Planning & Zoning Board

ZON24-00998 Highlights

- Rezone from RM-2 to RM-4 with a BIZ Overlay
- Site Plan Review for a 15-unit multiple residence development

Work Session June 10, 2025

Bonus Intensity Zone – Open Space / Amenities

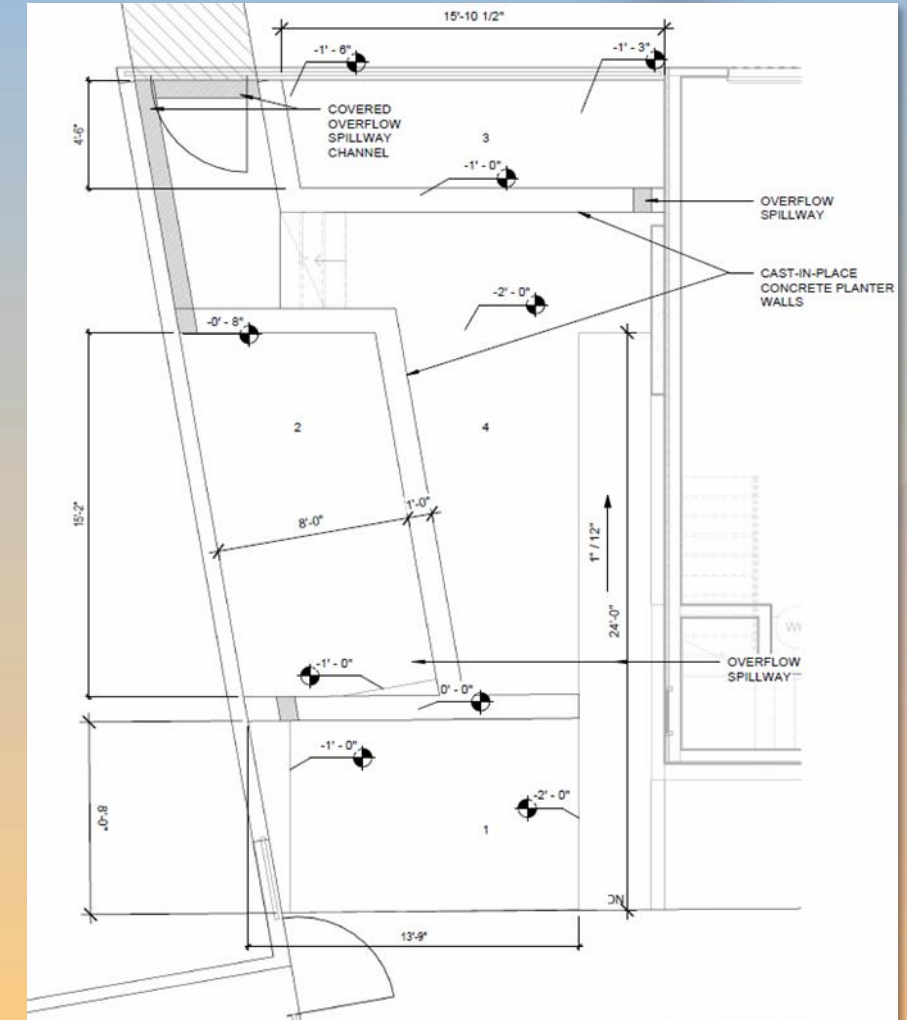
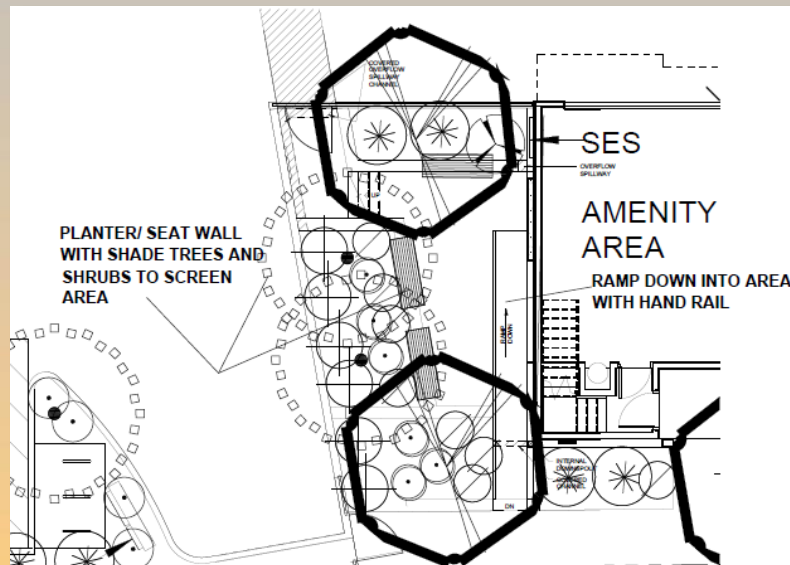
- Tiered garden concept is nice, provide larger area [Larger planters provided](#)
- Increase the area of the amenity space [Due to site constraints, we can't enlarge the space, but a bonus area was added North of bldg 1](#)

- Paint SES to match adjacent walls [See revised site wall plan.](#)
- Planters are tight [See revised amenity area](#)
- Swap the sidewalks at the perimeter for the planters so that there is more space for landscaping [Sidewalks at perimeter are needed to access unit entries.](#)

Landscape Plan

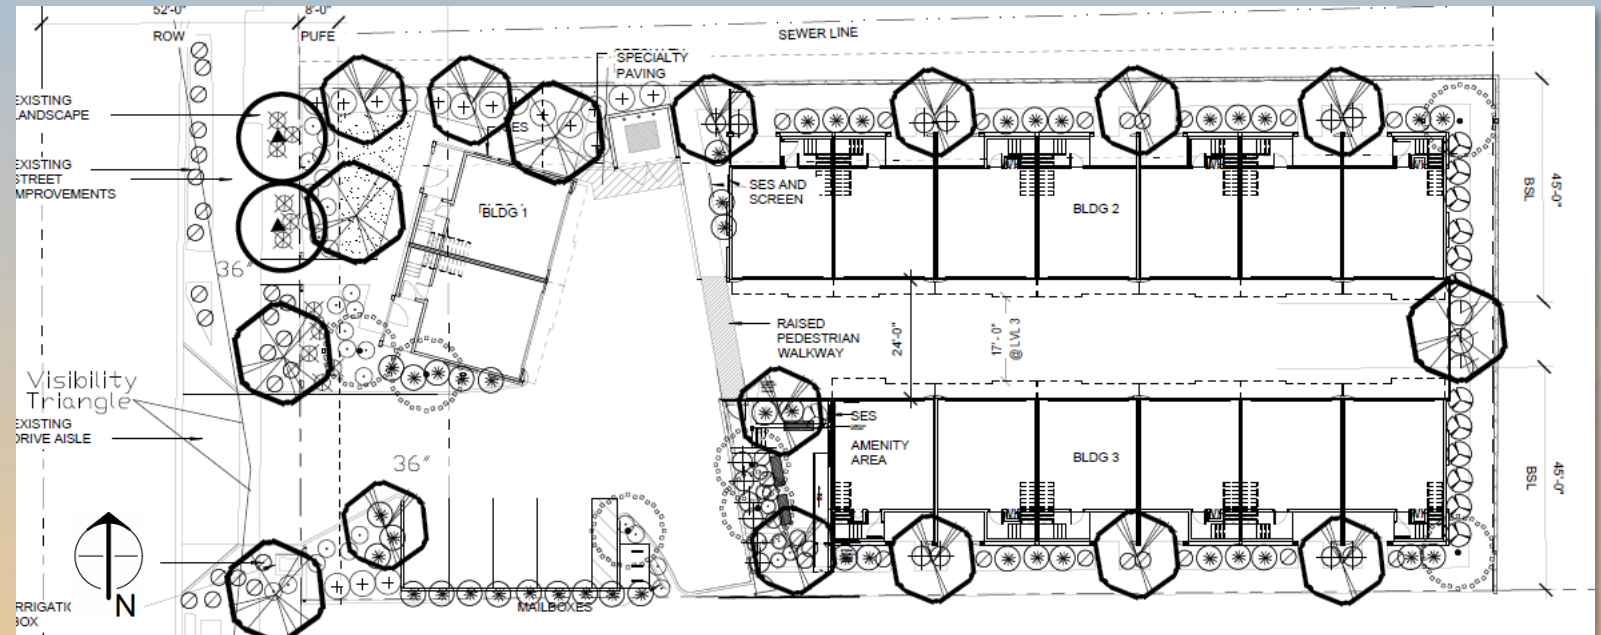
- Oaks drop sap (messy), also Oaks near the parking areas is problematic [See landscape](#)
- Taller trees needed [See landscape](#)

Elevations

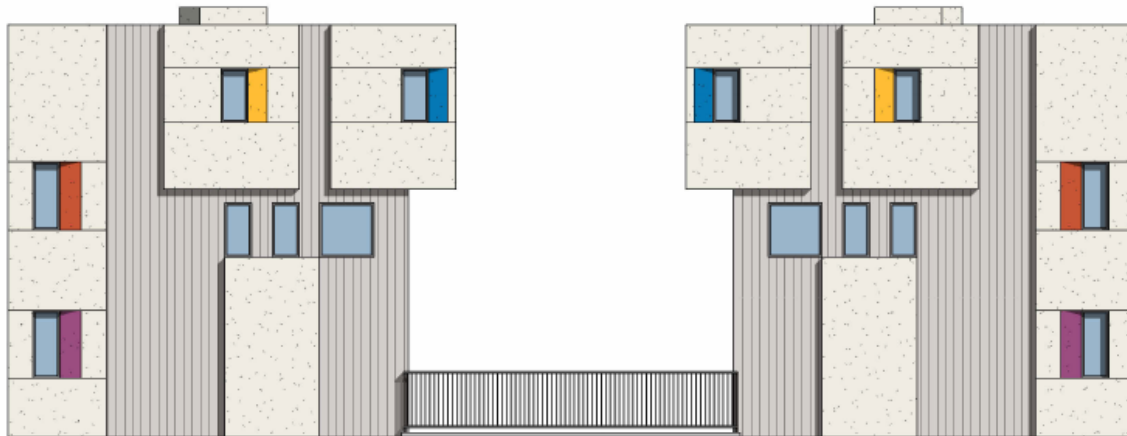
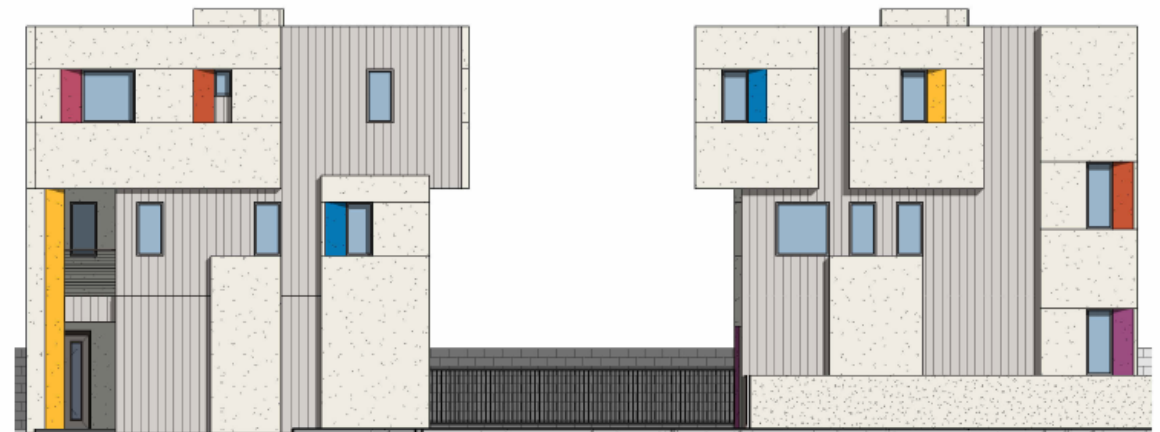
- Cubelike; not enough movement [See revised elevations](#)
- Needs additional movement on the non-garage side [See revised elevations](#)
- Wall articulation – 2nd story bump out 12" instead of 6" [Doing so would encroach on drive aisle width](#)

- Vertical siding entries should be at the 25% for the entry elevation [See revised elevations](#)
- Long-term maintenance of colors?
- Remove colors from top hats [See revised elevations](#)
